Subject: Upper Westside Specific Plan (PLNP2018-00284) Master Drainage Study – Resubmittal 3
Approval Letter

Subject: **Review of Upper Westside Planning Area Level 1 Master Drainage Study Report**

Wood Rodgers Response to Comments from Mead & Hunt's April 29, 2024 Review

Upper Westside Specific Plan - Master Drainage Study

Figure 3.1: Ag-Buffer Urban Interface

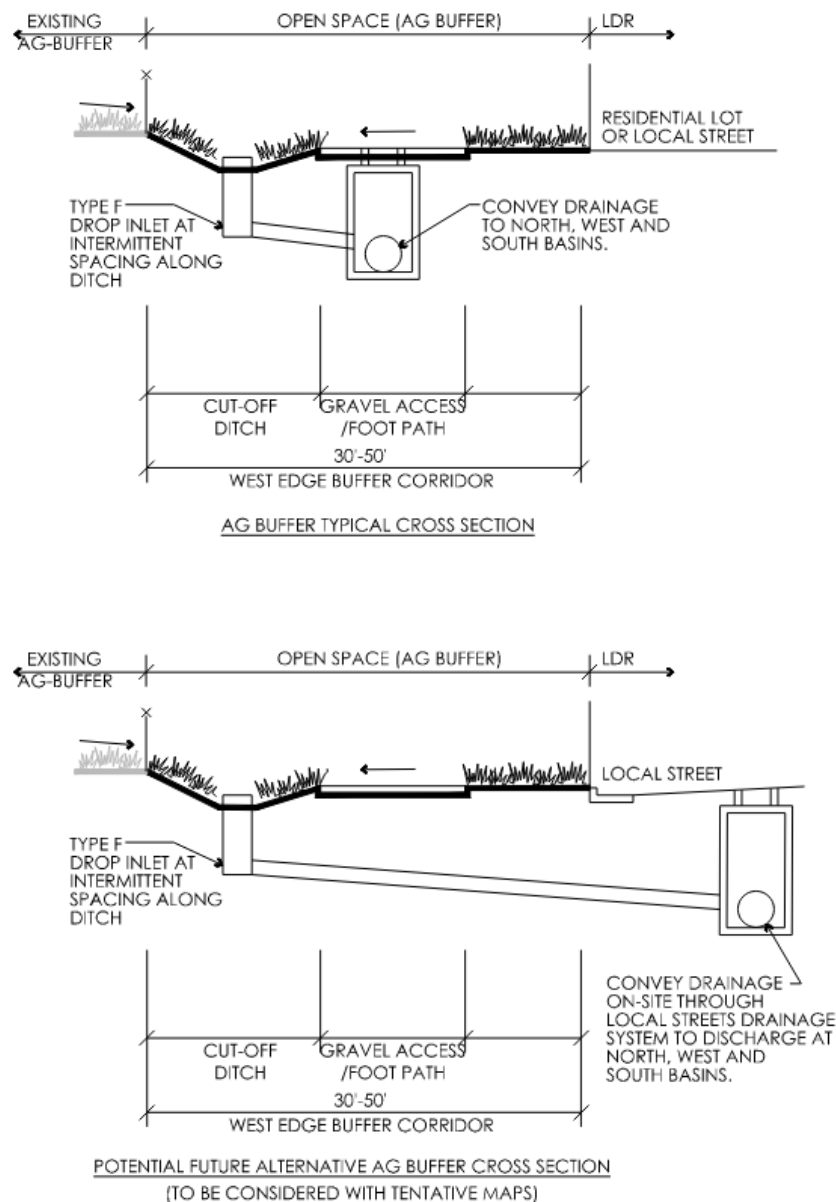
3.	Page 42, Figure 3.1 Ag-Buffer Urban Interface: The figure indicates ditch placed directly against the fenced Ag-Buffer with no access to permit maintenance along the left bank. Notes indicate this is "To be considered with tentative maps." It is assumed that this facility will not be operated and maintained by RD1000, please confirm intent (see above).	Added, "Drainage facilities along the ag-buffer constructed to convey runoff per County Standards will be operated and maintained by the County."

FIGURE 4.6

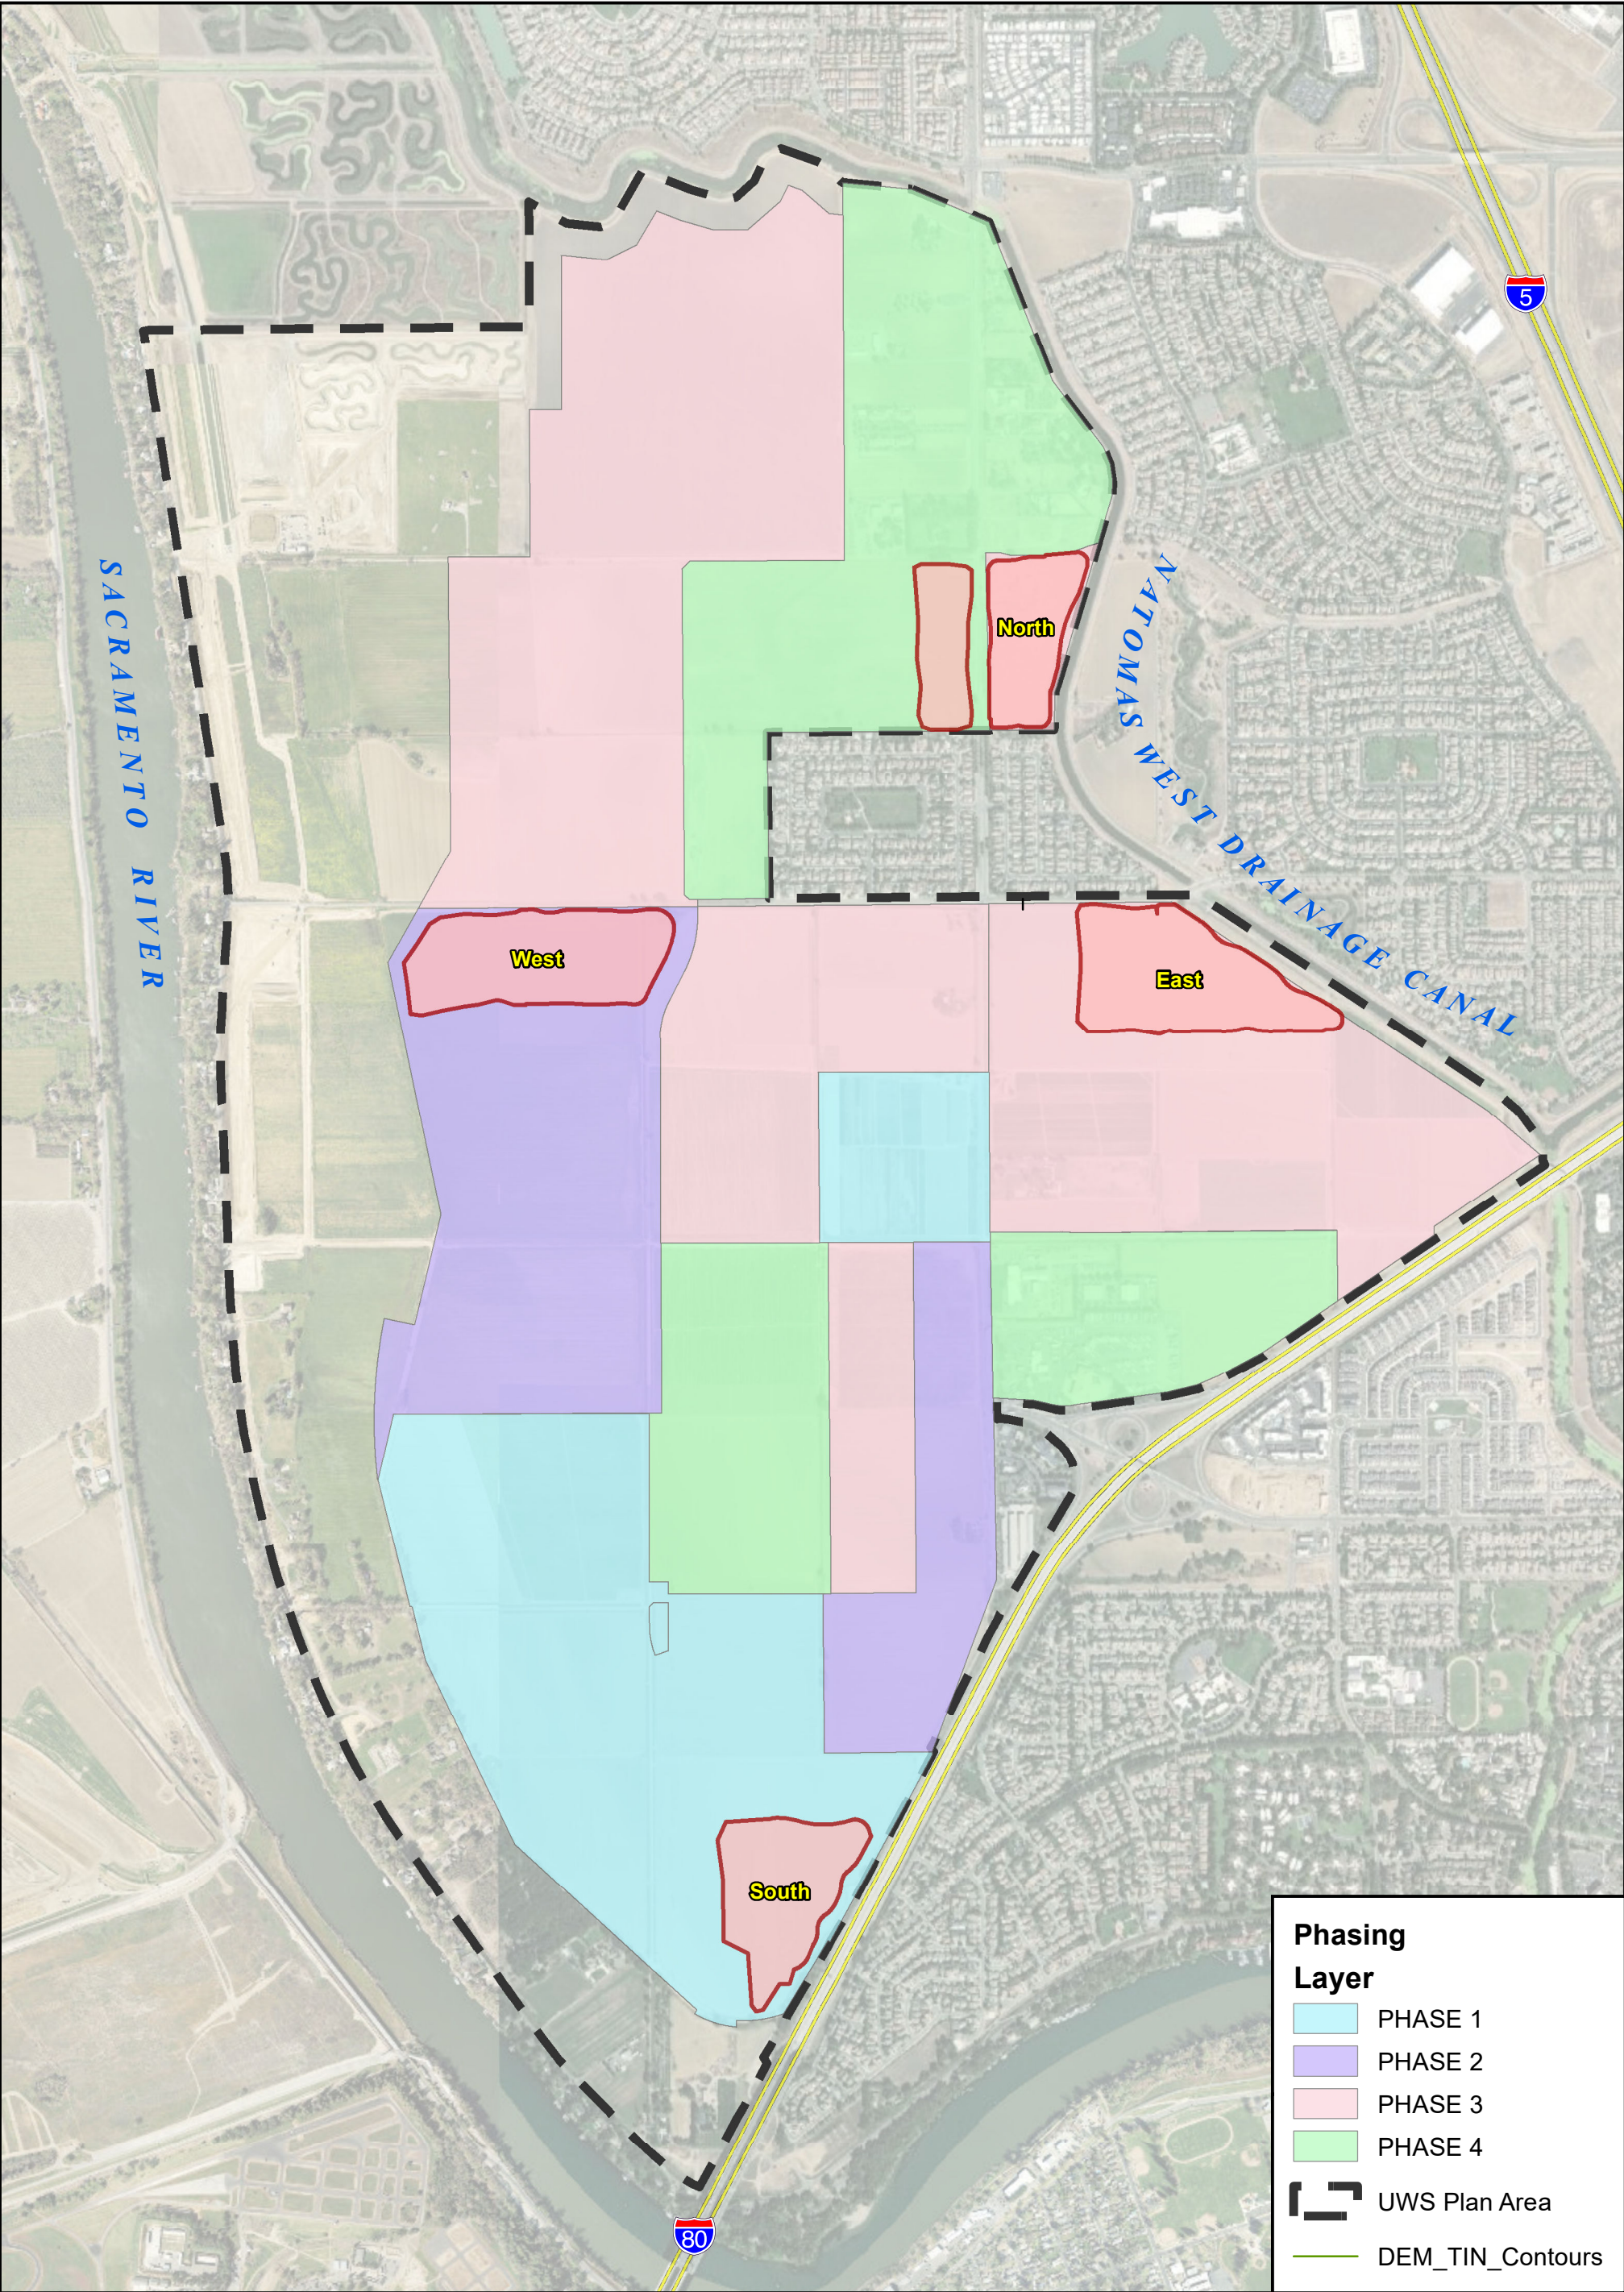
#	Submittal Comment	Wood Rodgers Response
	a. The reference Figure 4.6 contains no topographic labeling and is therefore difficult to confirm assumptions. Include labeling of elevation contours.	Comment addressed in updated Figure 4.6.
